QUESTIONS AND ANSWERS -

IFB #090324VK - Raleigh Bartlett Elementary and Geeter K-8 Roof Replacement

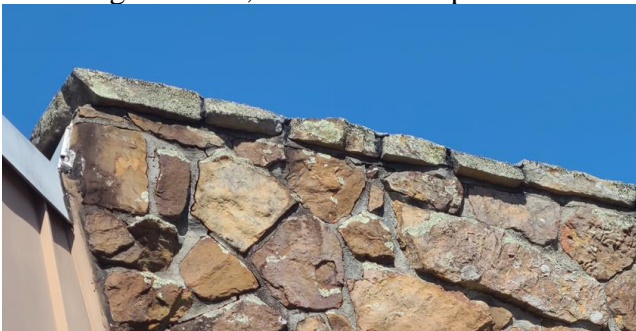
25. At Raleigh Bartlett, does the scope of work include the concrete “eyebrow” projections at the metal mansard roofs? If so, what is that scope?

Install 24-gauge aluminum coping over existing concrete eyebrow projections and install per the building envelope provider/Architect recommendations. Color shall be determined later.
